SECY-01-0138

SUBJECT: REMOVAL OF CABOT CORPORATION'S REVERE SITE FROM THE  
SITE DECOMMISSIONING MANAGEMENT PLAN

ENVIRONMENTAL ASSESSMENT  
OF SITE DECOMMISSIONING PLAN AND RADIOLOGICAL ASSESSMENT  
FOR CABOT PERFORMANCE MATERIALS, REVERE, PA

DOCKET NO. 40-9027  
LICENSE NO. SMC-1562  
LICENSEE: CABOT PERFORMANCE MATERIALS, REVERE, PA  
SUBJECT: SAFETY EVALUATION REPORT, SITE  
DECOMMISSIONING PLAN, AND RADIOLOGICAL  
ASSESSMENT, DATED MAY 24, 2001

**Figure 1.** Generalized conceptual model used in the Cabot-Revere assessment.

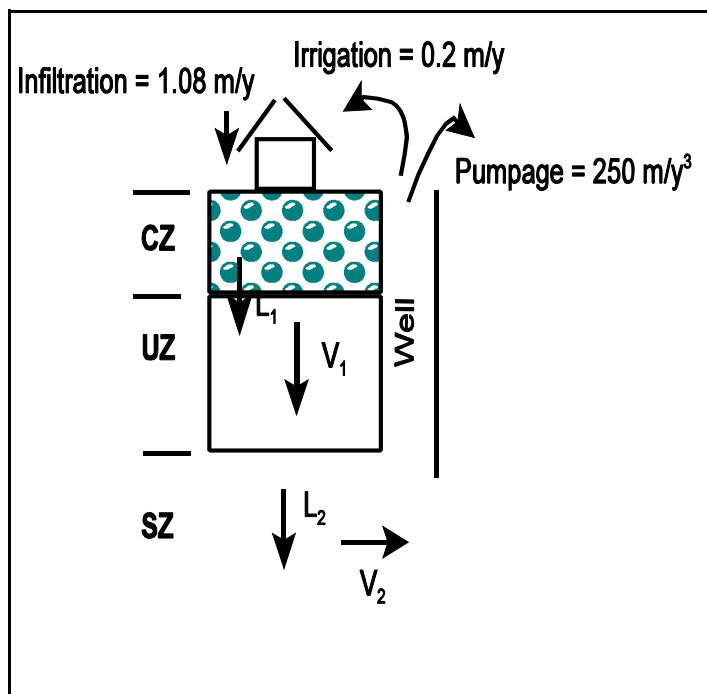
Figure 1 shows a schematic of the general conceptual model used in the Cabot-Revere RA, based on the staff's interpretation of the information presented in the report.
